# SITE PLAN & ARCHITECTURAL COMMISSION AGENDA APRIL 5, 2019

PROJECT KFC  
Applicant: Barry Thiriot  
Agent: Phillip Moss

FILE NO. AC-18-126

DATE March 15, 2019

**LANDSCAPE TABLE – Frontage Landscaping**

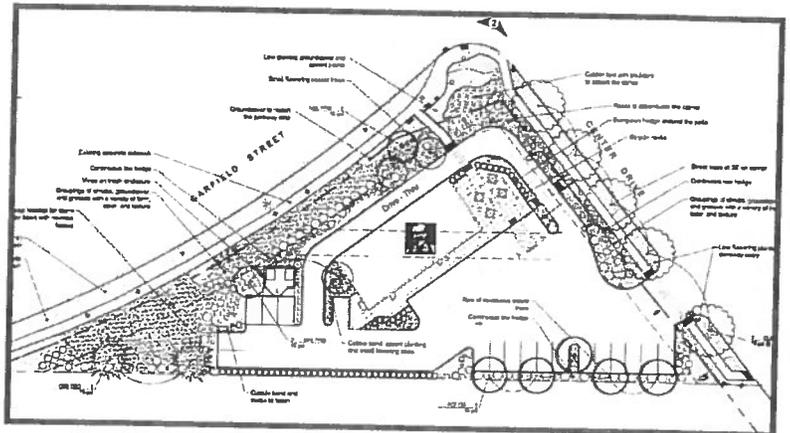
The submitted landscape plan (Exhibit H-1), shows landscaping along both frontages of the site, and located within the parking area; however, the plan is deficient the minimum number of trees required along the site's frontage with Center Drive.

As a condition of approval, the applicant will be required to submit a revised landscape plan showing the requisite frontage landscaping, pursuant to MLDC 10.746 and MLDC 10.797.

*Pedestrian Access*

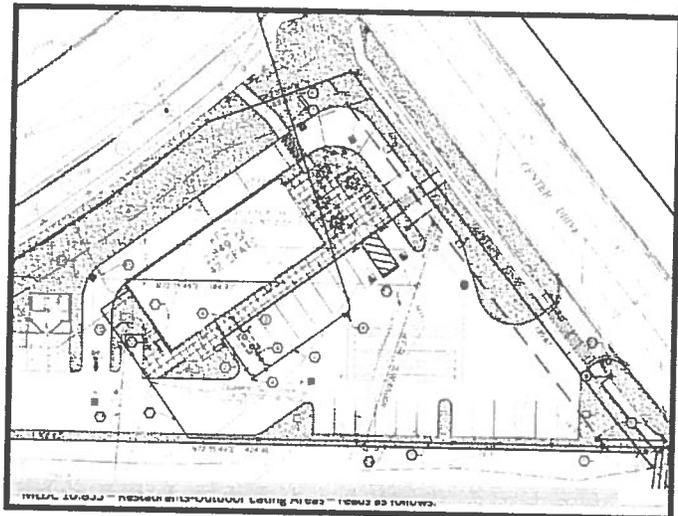
The site plan shows pedestrian walkways connecting the proposed building to the public sidewalks running along Garfield Street and Center Drive, consistent with the Pedestrian connectivity standards found in MLDC 10.772-776. However, no such connection is shown between the building and the abutting right-of-way of Belknap Road to the south.

As a condition of approval, the applicant will be required to show a pedestrian walkway connecting the proposed building to the abutting right-of-way of Belknap Road to the south, consistent with the pedestrian connectivity standards found in MLDC 10.722-776, prior to the issuance of building permits for vertical construction.

Outdoor seating

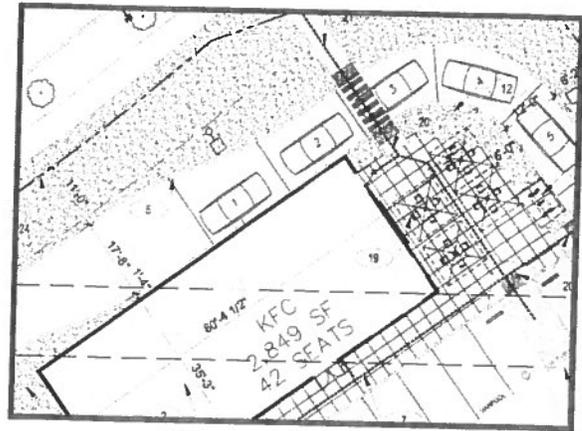
The submitted site plan shows four sets of four seats under umbrellas to be located outdoors within the front patio of the building.

Staff is supportive of the applicant's request to be approved for up to 16 seats on the restaurant's exterior patio, as it is staff's view that the submitted site plan shows sufficient space to accommodate the additional seating.

Pedestrian Walkways

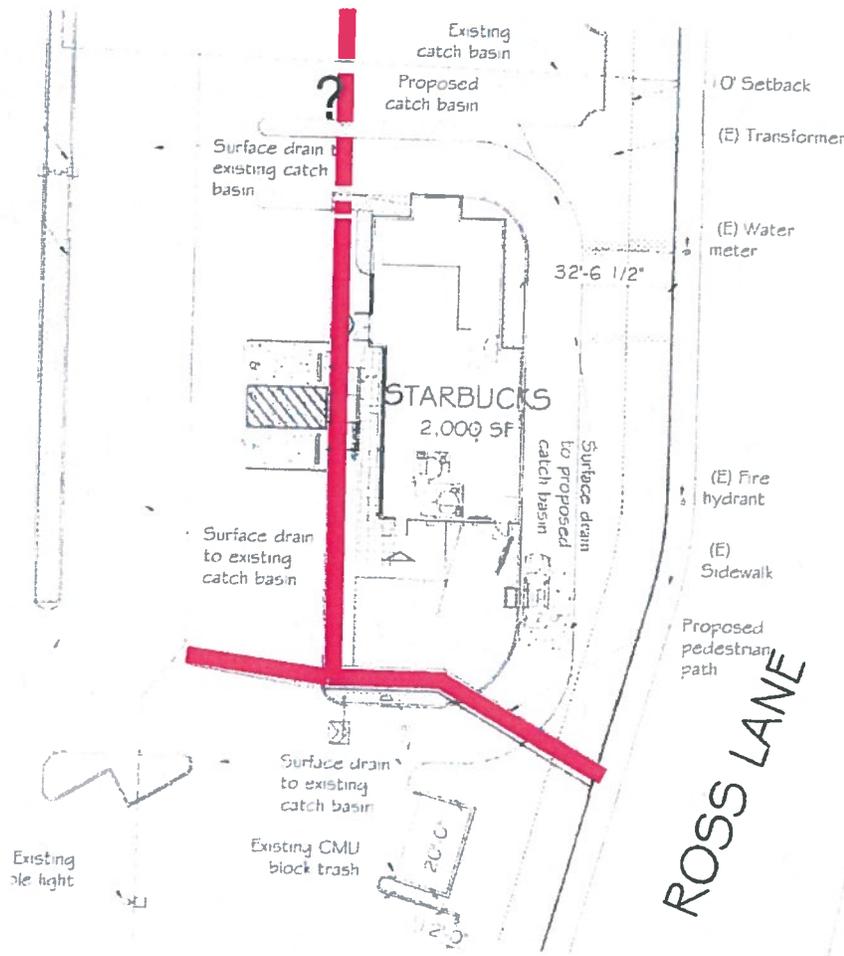
Proposed is a pedestrian pathway that extends from the sidewalk along Ross Lane to a pathway along the proposed structure which then also connects to the existing retail structure to the west.

MLDC 10.773 requires pedestrian walkways to connect to adjacent properties. It will be a condition of approval to submit a revised site plan illustrating a pedestrian connection between the subject property and the property to the north.

**Frontage Landscaping Table (10.797)  
(Based on Project Area)**

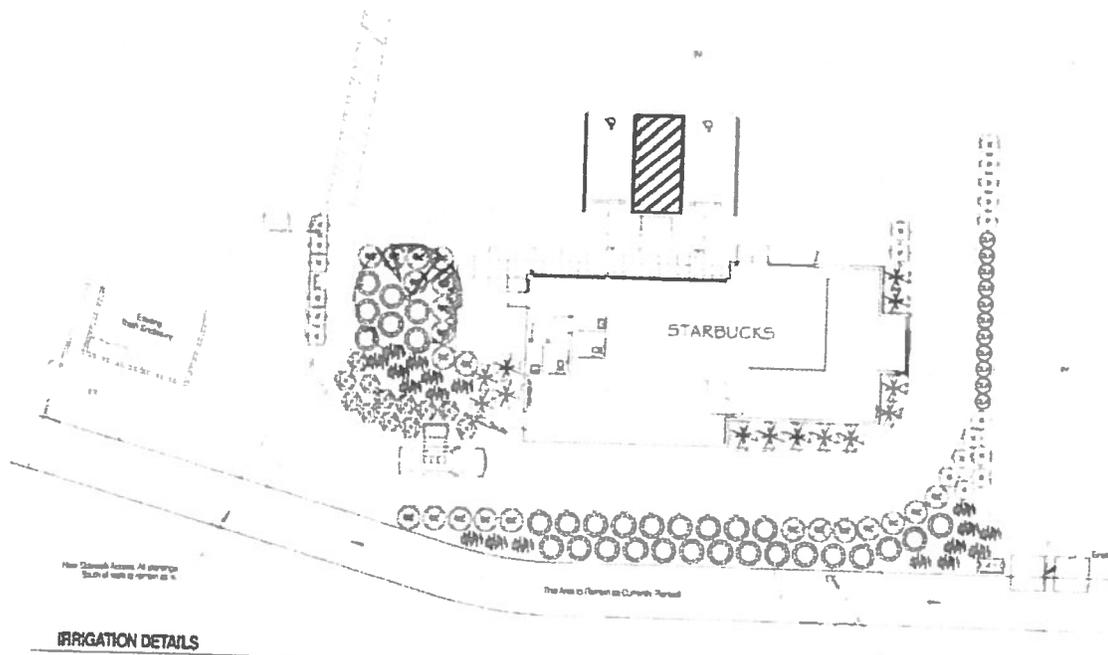
The project area stretches approximately 200 feet along Ross Lane. The submitted landscape plan does not conform to Section 10.797 regarding the required amount of street frontage landscaping trees. It will be a condition of approval for the applicant to submit a revised landscape plan conforming to Section 10.797.
